# Access Compliance Report

## Public Rights-of-Way

### (Curb Ramps)

Intersection ID: 45184	Main Street: HOLDEN_CT	Cross Street: TORRELLE_DR	Location: NE
ADA ID: 95DAA06BA52F	Ramp Type: BlendTrans1	Initial Pass/Fail: Fail	Overall Compliance: No
Severity Score: 8.75			
Codes/Mitigation Info/Possible Solution		Field Measurements/Component Compliance

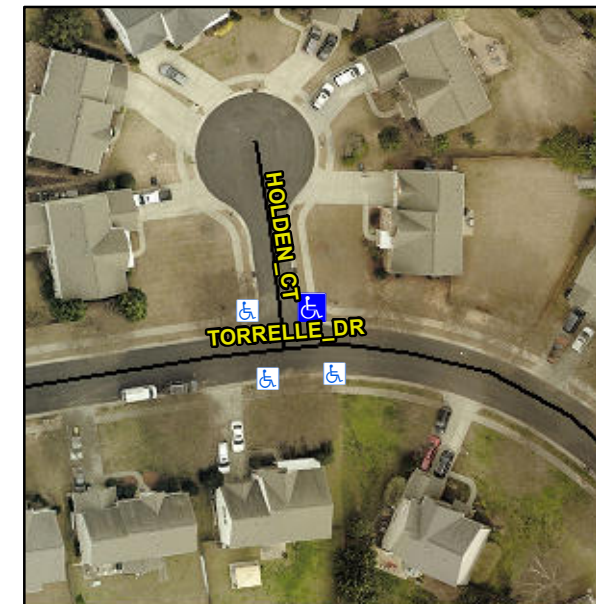
**Not Found, R304.5.1**

Compliance	Description	Data	Compliance	Description	Data
N/A	Ramp Length (in)	46.0	Yes	BlendTrans Slope (%)	1.3
No	Ramp Width (in)	46.0	Yes	BlendTrans XSlope (%)	0.1
N/A	Flare Type LT	N/A	N/A	Flare Type RT	N/A
N/A	Flare Slope LT (%)	N/A	N/A	Flare Slope RT (%)	N/A
N/A	Flare Traversable LT?	N/A	N/A	Flare Traversable RT?	N/A
N/A	Landing Length (in)	N/A	N/A	DWS Provided?	N/A
N/A	Landing Width (in)	N/A	N/A	DWS Contrast?	N/A
N/A	Landing Slope (%)	N/A	N/A	DWS Length (in)	N/A
N/A	Landing X Slope (%)	N/A	N/A	DWS Full Width?	N/A
N/A	Landing Curb? (Y/N)	N/A	N/A	DWS Offset (in)	N/A
N/A	Shared Landing?	N/A			
N/A	Gutter Ponding?	N/A	N/A	Gutter Slope (%)	N/A
N/A	Gutter Lip Ht (in)	N/A	N/A	Gutter X Slope (%)	N/A
N/A	Painted X Walk1?	No	N/A	Painted X Walk2?	No
	X Walk 1 Direction	To W		X Walk 2 Direction	To S
	X Walk 1 Width (in)	N/A		X Walk 2 Width (in)	N/A
	X Walk 1 Slope (%)	1.3		X Walk 2 Slope (%)	1.5
	X Walk 1 X Slope (%)	1.1		X Walk 2 X Slope (%)	1.7

N/A	Ramp inside XWalk1?	N/A	N/A	Ramp inside XWalk2?	N/A
	Road Slope (%)	1.0		Clear Space?	N/A
	Road X Slope (%)	1.2	N/A	Clear Space to XWalk (in)	N/A
N/A	Any Obstructions?	N/A	N/A	Storm Grate/Utility Hazard?	N/A
	Obstruction Type			Storm Grate/Utility Type	
		N/A			N/A
			Yes	Surface Condition? (G/P)	Good
			No	Curb Slope (%)	12.5

**Remove & Replace Curb Ramp With Two New Directional Ramps or Equivalent.**
